NO: TB-SC-001

# TECHNICAL BULLETIN

**MODEL AFFECTED:** SPORTCRUISER

**SUBJECT:** FLAPS CONTROL SYSTEM

DRAWING 1 – INITIAL SITUATION

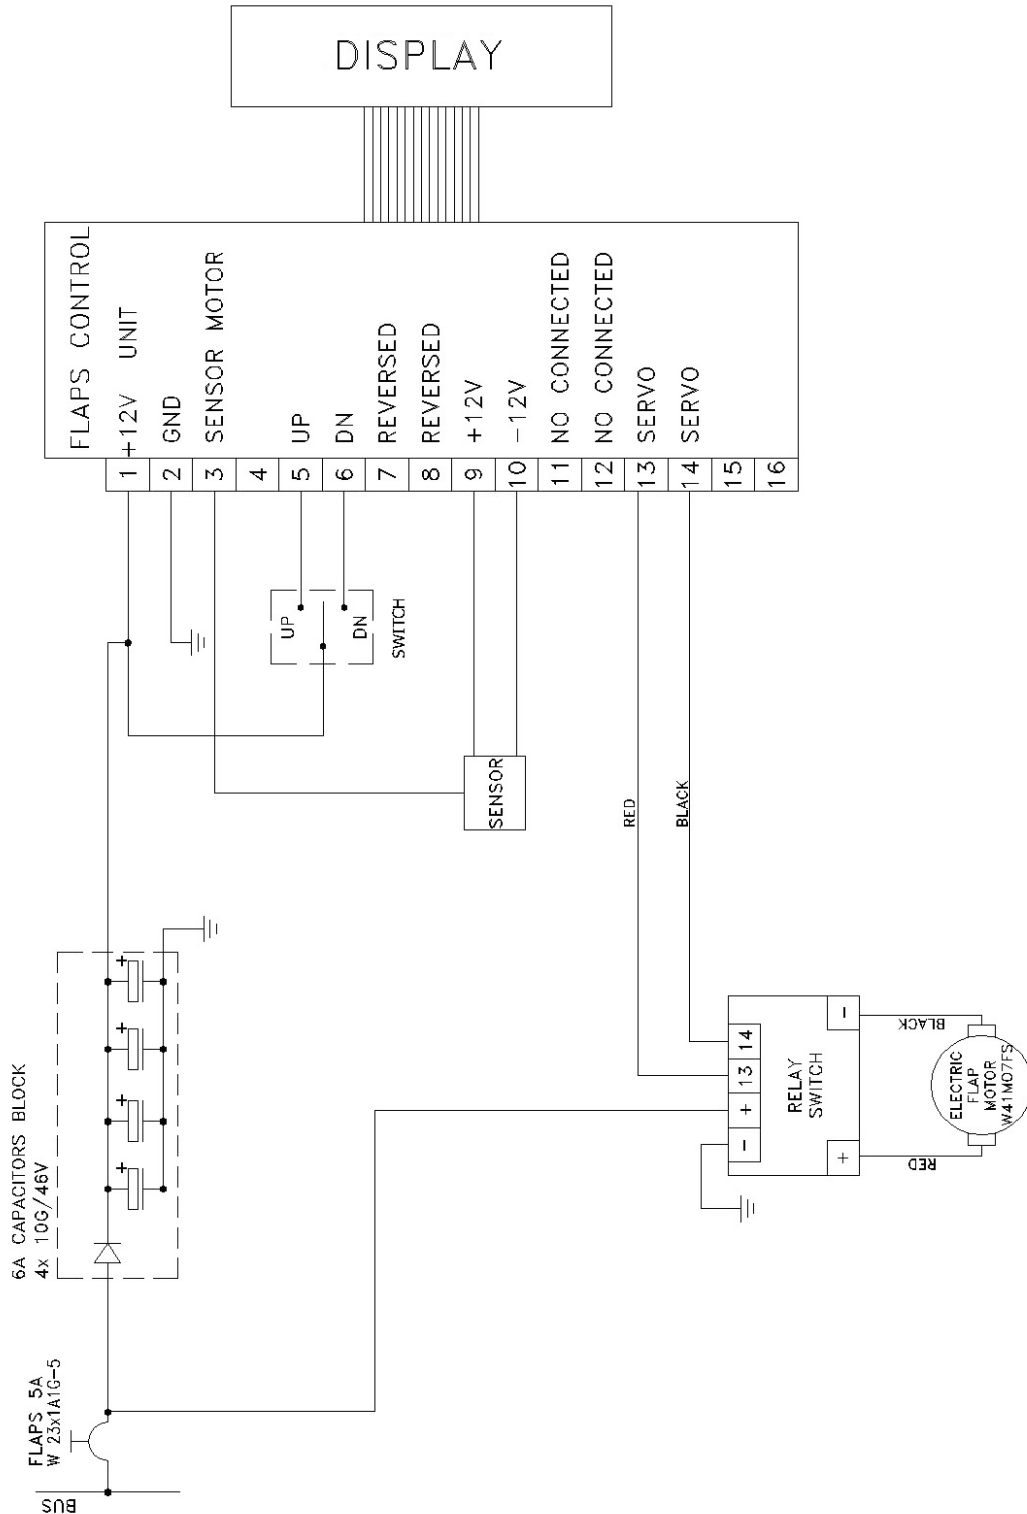
4. Left instrument panel, flaps control unit. See DRAWING 1
  - a. Disconnect RED wire (positive) from fuse „FLAPS“
  - b. Disconnect BLACK wire (GND)
  - c. Disconnect wires to flaps actuator – RED (13) and Black (14)

- d. Disconnect wires (gray bandaged), (3), (9), (10). There could be used GREEN, YELLOW, BROWN, or ORRANGE, BLUE, GREEN.

DRAWING 2 – MODIFIED FLAPS CONTROL SYSTEM

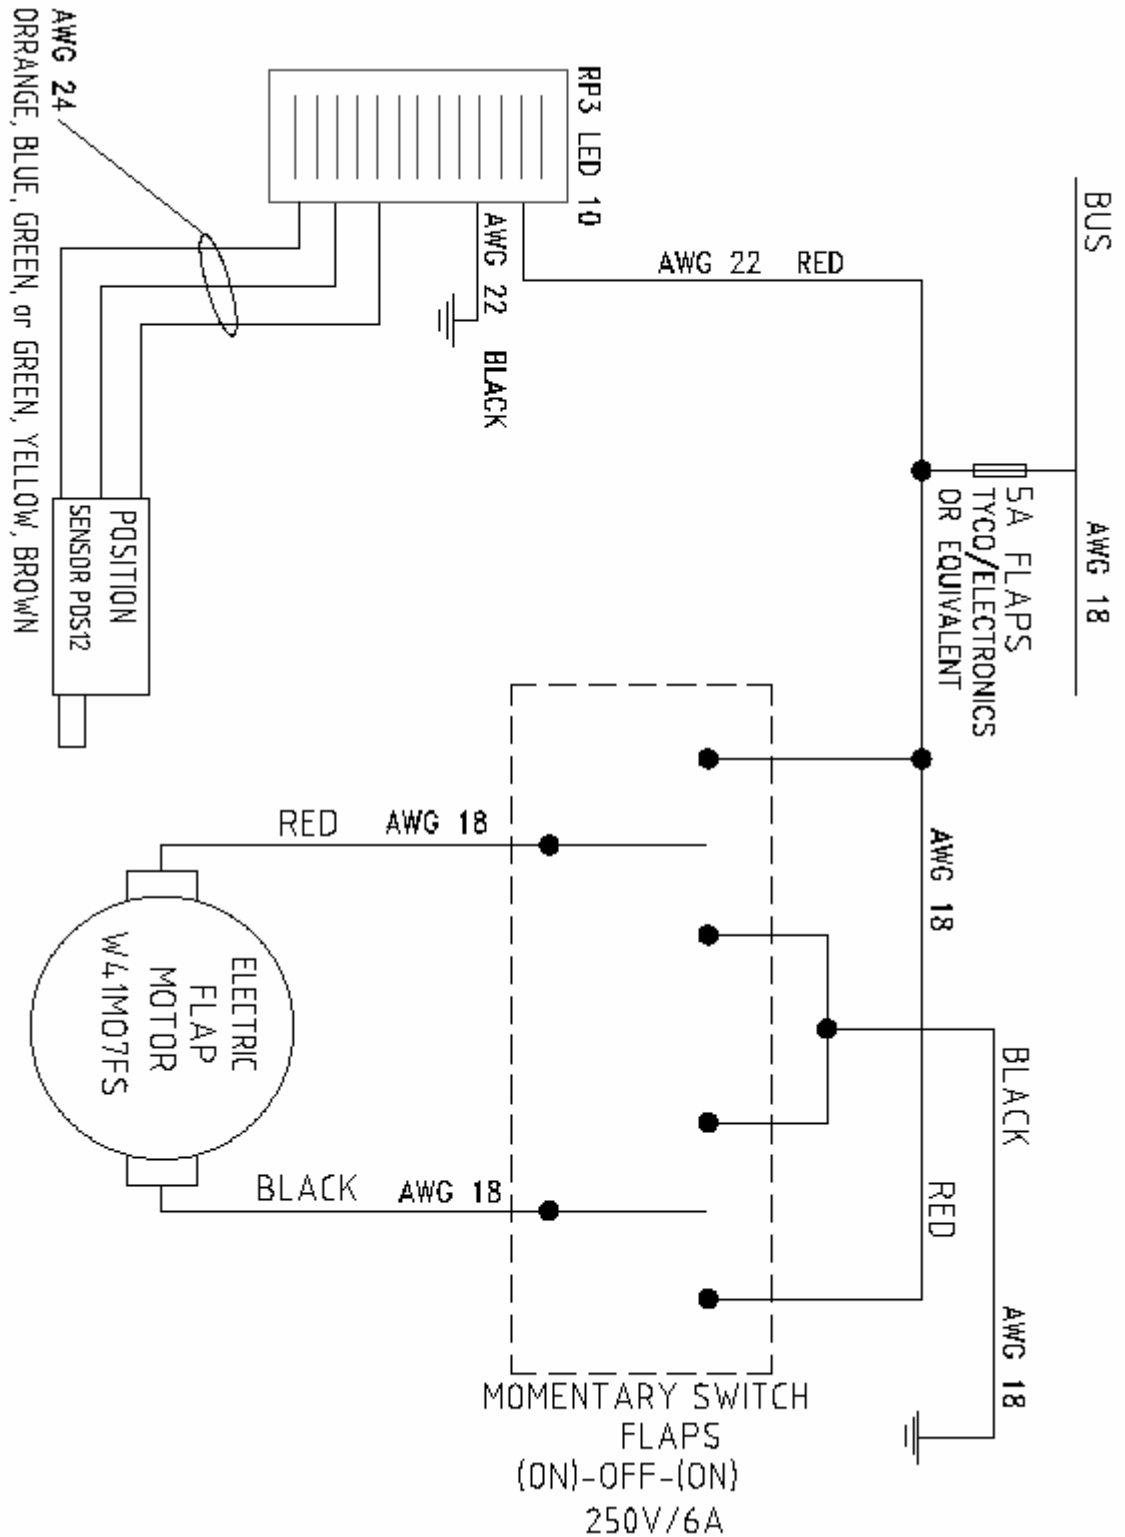
This bulletin introduces more reliable flaps control system that is manually controlled with LED position indication.

14. Connect wiring POS12 (GREEN, YELLOW, BROWN, or ORRANGE, BLUE, GREEN) to RP3 Flaps position LED indicator according to Drawing 3
15. Connect wiring RP3 to Flaps fuse (RED) and Ground (BLACK) according to Drawing 3

16. Connect wiring to flaps control switch according to Drawing 3.
17. Check wiring for proper attachment, insulation, security.
18. Install removed instrument panel and central console, install access covers.

DRAWING 3 – FLAPS POSITION SENSOR INSTALATION

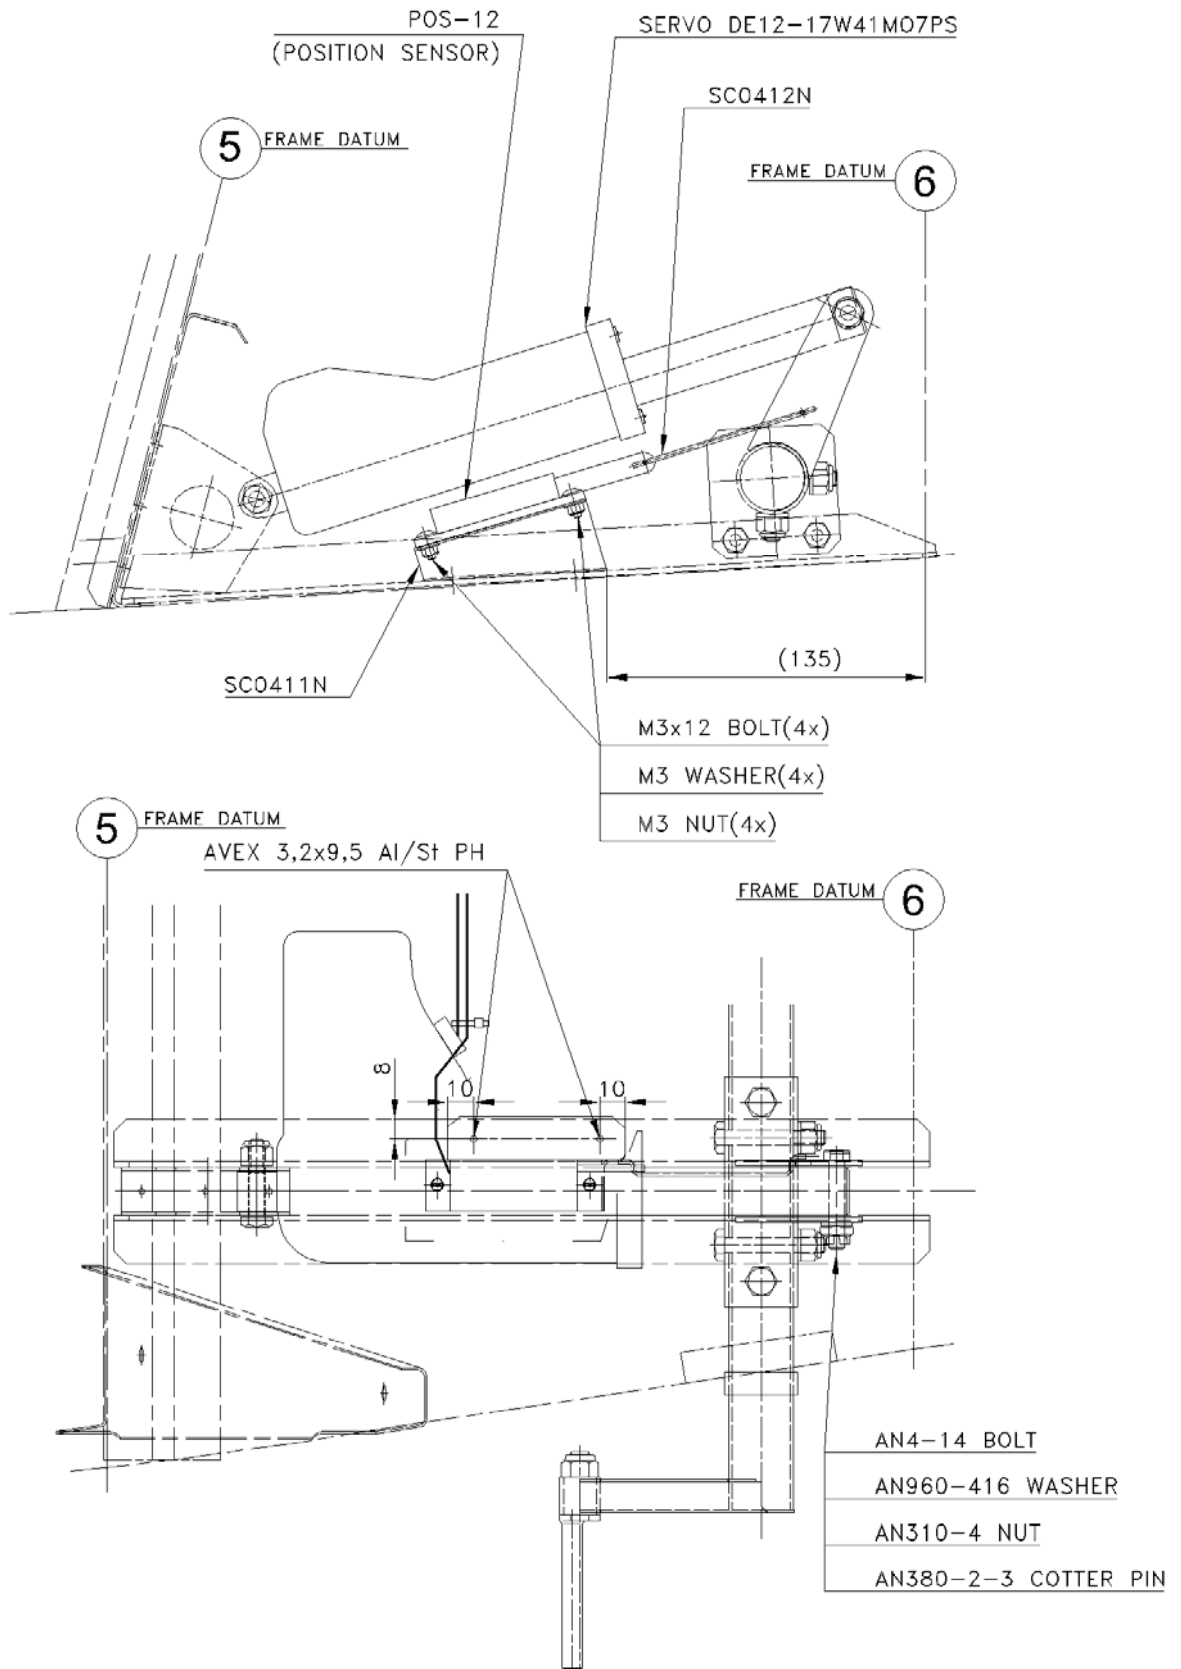
8. Remove access cover in baggage area. Refer to SPORTCRUISER MIP, Chapter 6.3.4
9. Remove flaps position sensor unit including console.
10. Remove Bolt AN4-23A, install Bolt AN4-14, see DRAWING 3

12. Install new Flaps position sensor POS12 attached on Bracket SC411N under actuator according to Drawing 3
13. Connect POS12 to flaps control lever by the Rod SC0412N.
